Product Change Notification: SYST-17GFQM067

PIC18F26/46/56Q84 Silicon Errata and Data Sheet Clarifications

SYST-17GFQM067

1.6.1. UART TXDE Signal May Go Low Before the STOP Bit Has Been Entirely Transmitted

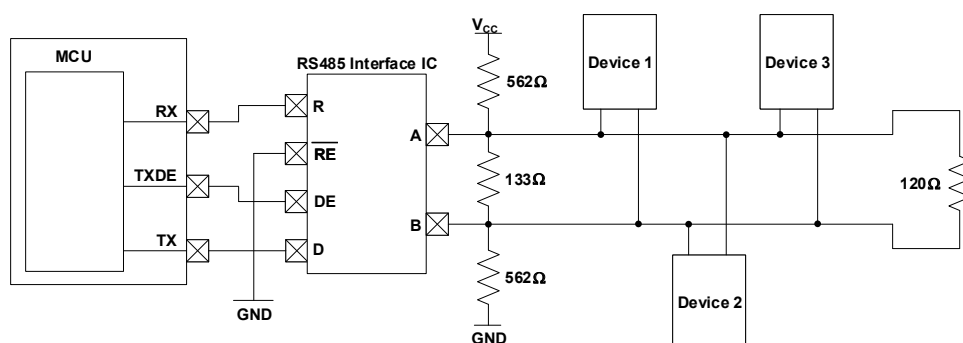
The UART Transmit Drive Enable (TXDE) signal could potentially transition into a low state before the UART Stop bit has been entirely transmitted due to the effects of parasitic capacitance on the TX line. In some applications, this could result in communication being prematurely terminated due to the TXDE signal going low before the STOP bit has had enough time to settle.

To ensure that the Stop bit settles into its final logic state before the TXDE signal transitions low, a biasing circuit can be implemented. A biasing circuit allows the TX line to either be driven high or low, rather than being left in a floating tri-state mode, where prolonged rise or fall times could lead to communication being disrupted. This bias circuit must only be implemented on one end of the serial bus, and a termination resistor must be used on the other end. The figure below shows an example of a bias circuit that can be used to achieve this.

Please note that the resistor values used in this circuit are recommendations and that the actual resistor values required may vary based on the application.

48-Lead Plastic Thin Quad Flatpack (Y8X) - 7x7x1.0 mm Body [TQFP]

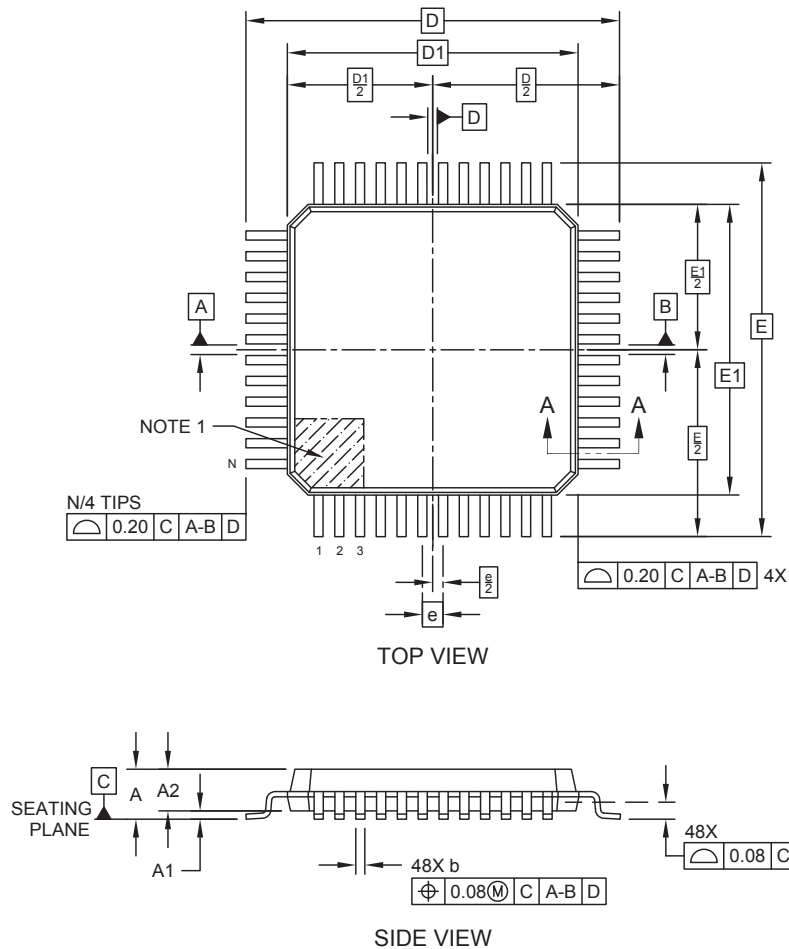
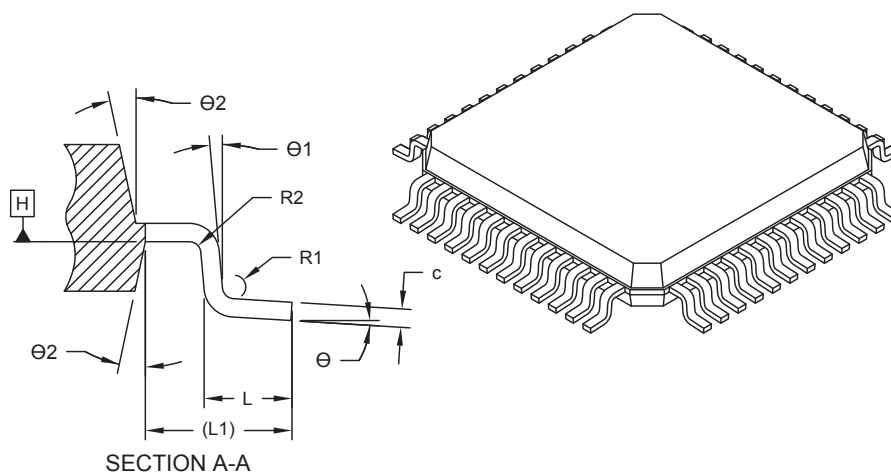
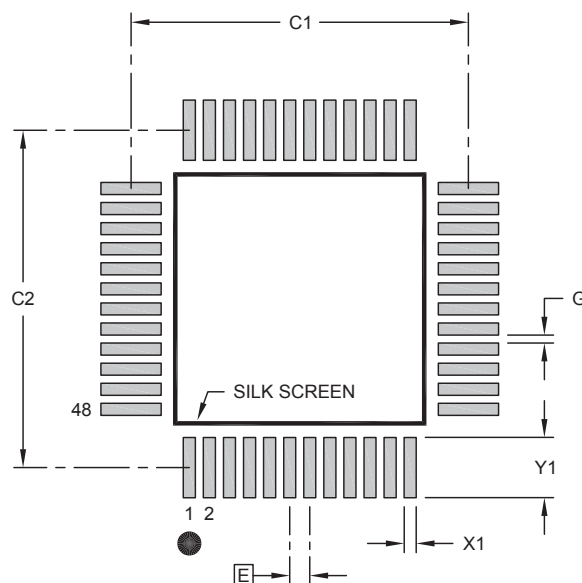
The data sheet lists the incorrect package drawing for the 48-lead TQFP package. The correct package drawings are shown below:
